ROTHER VALLEY RAILWAY

Transport and Works Act 1992 (TWA):
Application for the Rother Valley Railway
(Bodium to Robertsbridge Junction) Order

Proof of Evidence: Flood Risk

Chris Patmore CEnv, BEng, DIP EIA, MIEEnvSci, MCIHT, MCIWEM, MICRS
Reference: TWA/18/APP/02/OBJ/1002

Figure 6.1: EA Flood Mapping – Extract from Product 4 data request by WSP 2018 (see OBJ/1002/CP/2 - Appendix C) – showing extent of Functional Flood Plain (5% AEP)

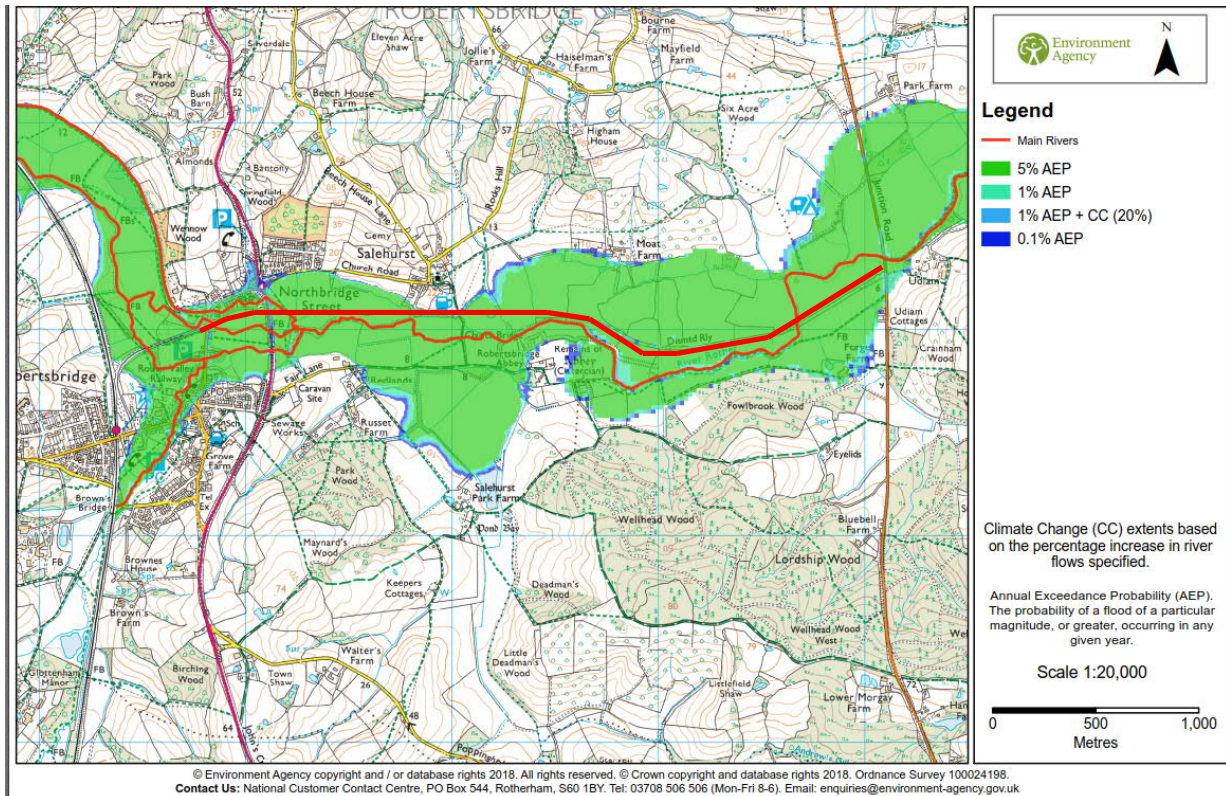
- 6.2.1. The EA mapping of this area dated 2018 (reproduced as **Figure 6.1** with the full mapping contained in **OBJ/1002/CP/2 - Appendix C**) clearly shows that the route of the railway is located within Flood Zone 3b – functional floodplain (the 5% AEP area hatched in green). The FRA also makes reference to the fact that the railway line crosses “the functional floodplain” of the River Rother (Section 3.2.4 of the 2016 FRA) which is an area designated Flood Zone 3b by the EA.

Figure 6.2: Capita Flood Mapping 2016 – Figure B-4 Difference in Maximum Depth Between “with railway” scenario and baseline scenarios for the 1% AEP Flood Event

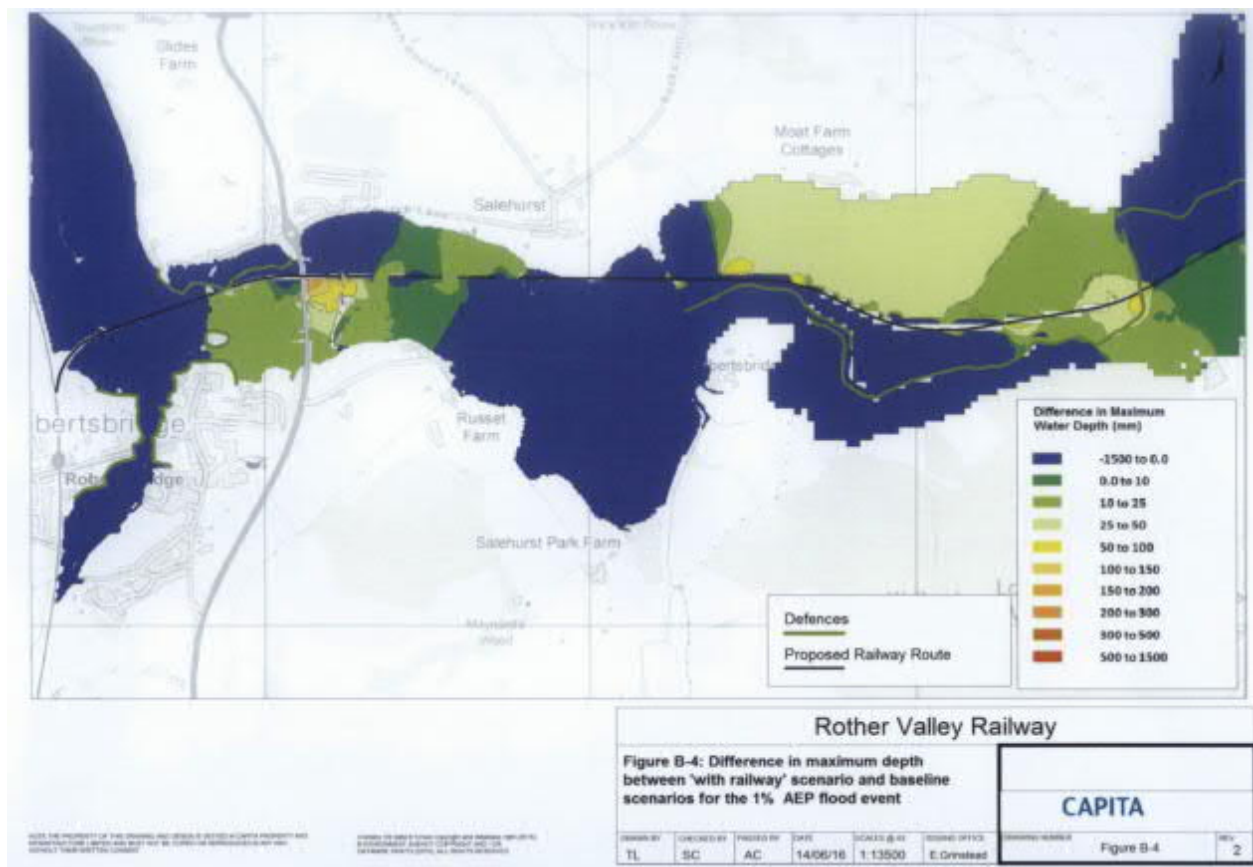
- 6.2.19. This mapping is potentially misleading as the “benefit” mapping (Dark Blue) shows a range from -1,500mm to 0mm suggesting all this area potentially benefits from the scheme but equally, with a 0mm value, very little of this area could benefit. The banding of the benefit is effectively hidden in one large value range whereas the impacted areas are in 50mm bands.

Figure 6.4a: Extract from Capita Flood Mapping 2020 – Figure 4-9 1% AEP Design Flood Event with 105% allowance for climate change - Difference in 'With Railway' and Baseline predicted Maximum Water Level

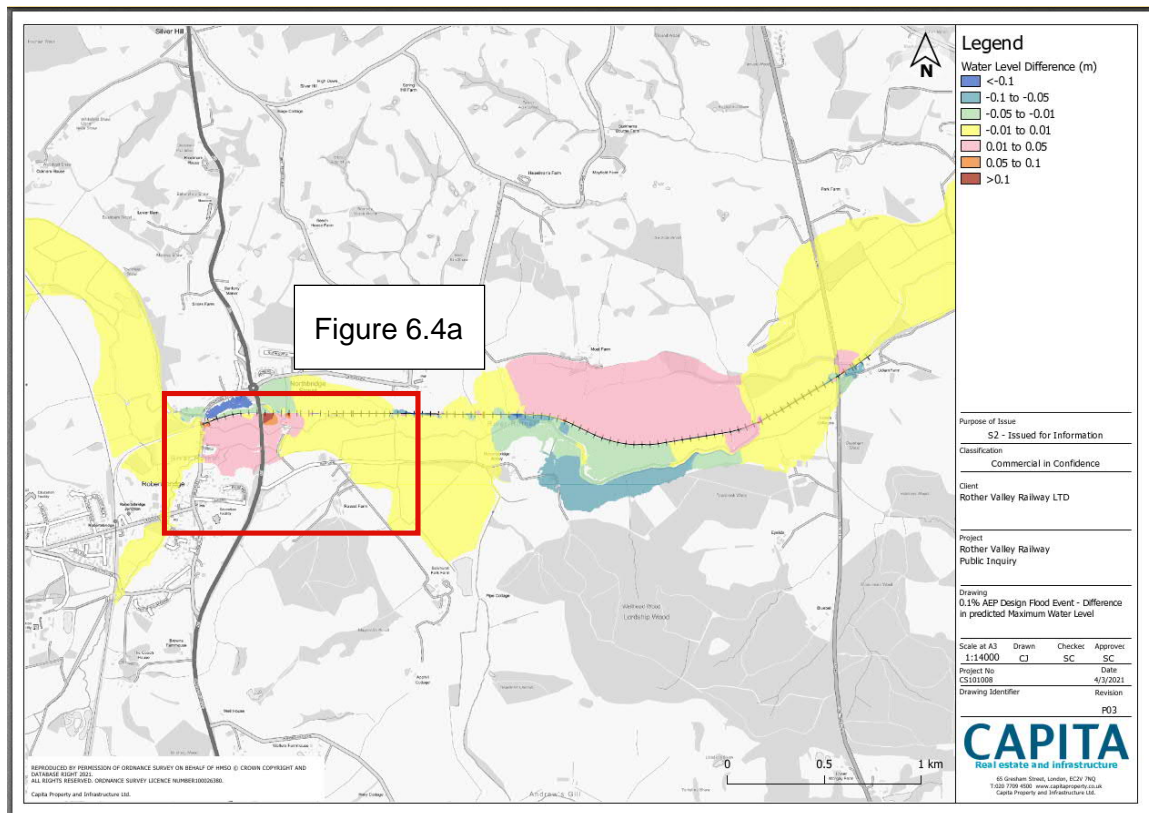
- 6.2.27. A deeper impacted area is shown in dark red on the plan (Figure 5.4a) and this corresponds to an area immediately adjacent to the A21 with a predicted water level increase of above 100mm. Again, this is within “only” agricultural land but immediately adjacent to important wider public infrastructure.

Figure 6.6: Extract from Capita FRA (2016) – Figure 6

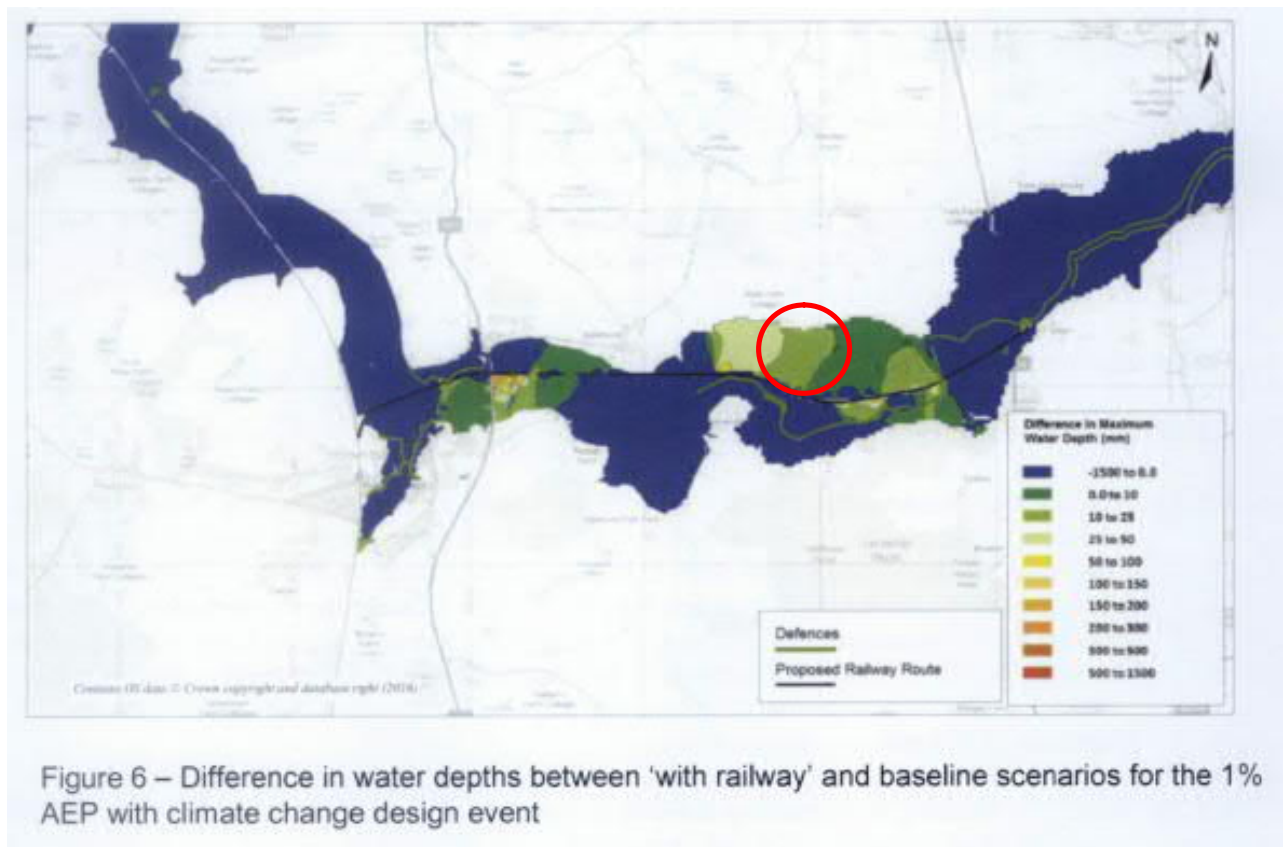
- 6.6.6. Taking the area highlighted on the above diagram (red circle) at an average increased water depth of 20mm over the area (estimated at 120,000m²) equates to a volume of approximately 2,400m³.

- 6.6.7. This is only one of the areas highlighted for an increase in flood depth. There are many others and some with a greater increase in predicted flood depth. Without the overall model details, it is very difficult to quantify the amount of additional flooded volume the scheme generates. Equally I do not know the volume in the areas of reduced flooding. It may be possible that the two volumes balance, but in my view, this is unlikely, considering the added physical volume of the railway embankment itself should also be considered in the calculations, that the two volumes balance. I have not seen any evidence that there would be no net loss. Indeed, the simple fact that the model mapping is showing areas with increased flooding shows that compensation has not been incorporated into the model. If compensation had been included, then there would be no perceptible change in flood extents.

Figure 6.9: Extract from Halcrow drawing RVR-G-001 Rev B

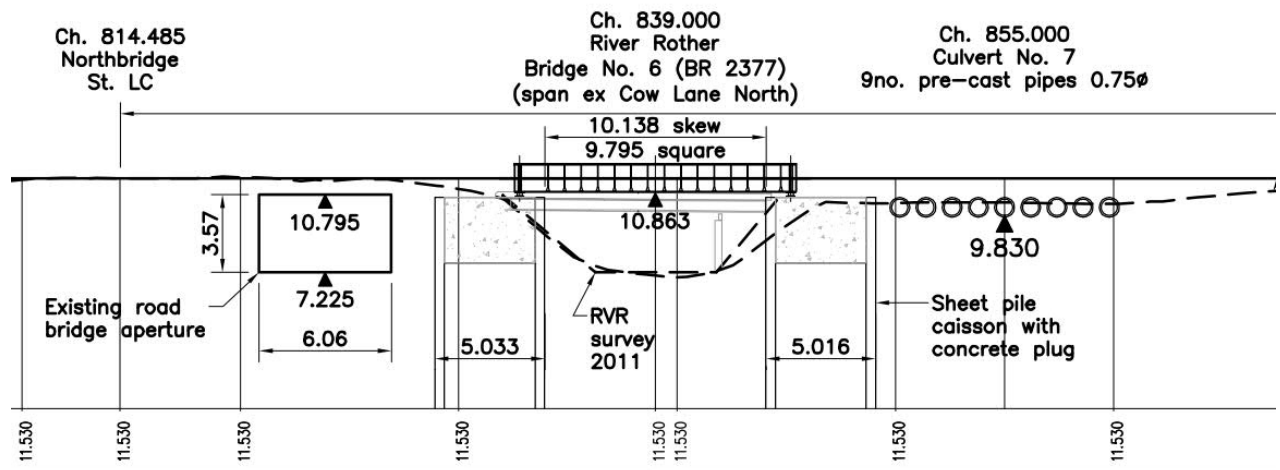
- 6.9.7. This increased number of crossing and structures has the potential to increase the occurrence of blockages and interference with the flood flow pathways. As discussed earlier in this proof, there does not appear to be any discussion or analysis of the impact of blockages on the flood plain operation or flood extents.

Figure 6.10: Buffer Strip Offset

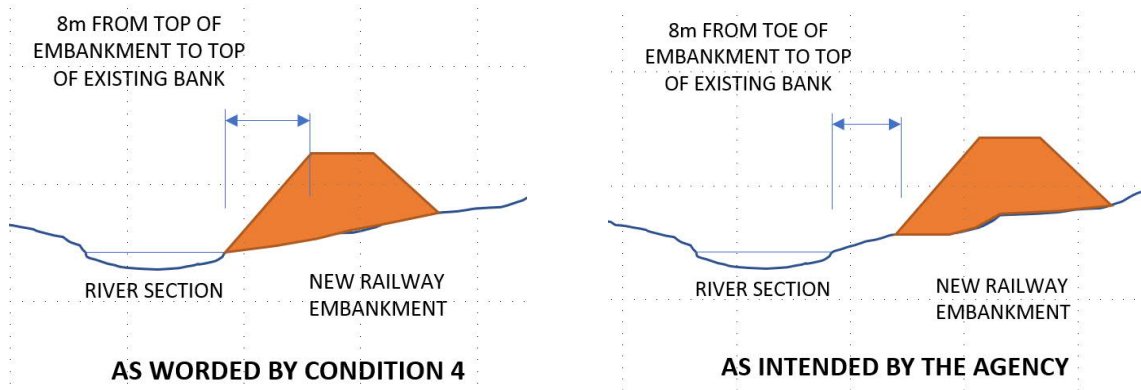
- 6.10.4. The word **“top”** is an incorrect, and significant, transcribing of the EA suggested planning condition and the word **“toe”** as contained in their letter to the Local Planning Authority dated 19 December 2016 (a copy is included as **OBJ/1002/CP/2 - Appendix A1**).

- 6.10.5. The sketch below (**Figure 6.10**) highlights the obvious difference as a result of the terms used. The buffer required is usually a flat or at least accessible area rather than a 1 in 3 or 1 in 2 slope as the railway embankment would be.

Figure 6.11: Between Existing Culvert/Bridge Structures 4 and 5

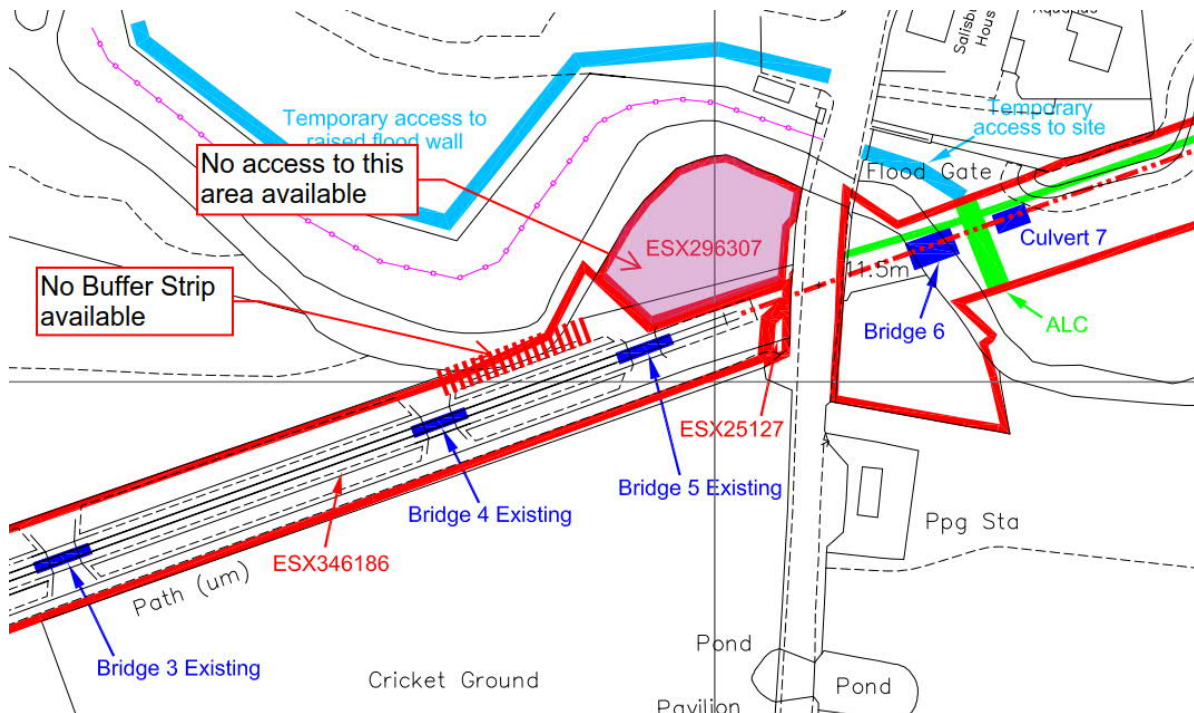
6.10.6. This is a particular concern where the proposed embankment / rail track is very close to the existing river and watercourses. The particular locations include:
